## Receiver Desensitisation in 9323 & 9360 Transceivers

Figure 1 Location of R273

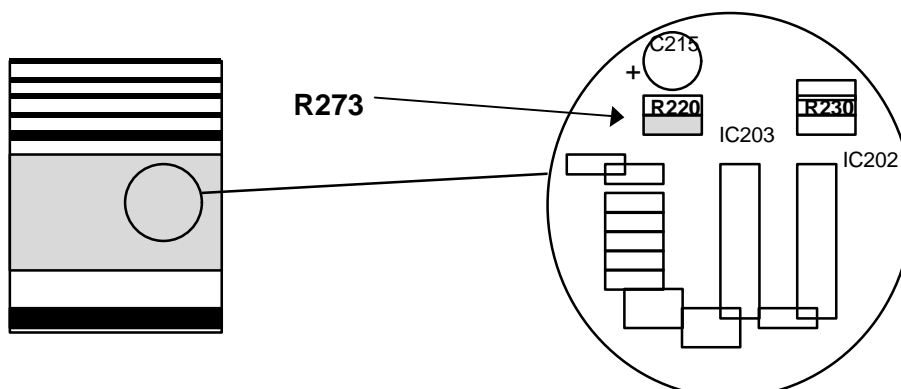
The introduction of Version 3 software redefined the use of the I/O (Input/Output) ports of IC209 on the Receiver/Exciter PCB (P/No 08-04962-001) within the transceiver. This change produced an effective desensitisation of the receiver of some 10dB. To overcome this, the line from Port 3 of IC209 (Pin 7) should be disconnected. This is best achieved by the removal of resistor R273. Once removed you should note an improvement in receiver performance. Transceivers factory fitted with Version 3 or later software already incorporate this modification.

4. Remove R273 from the PCB by carefully cutting both leads with a pair of side cutters.
5. Replace the transceiver top cover.
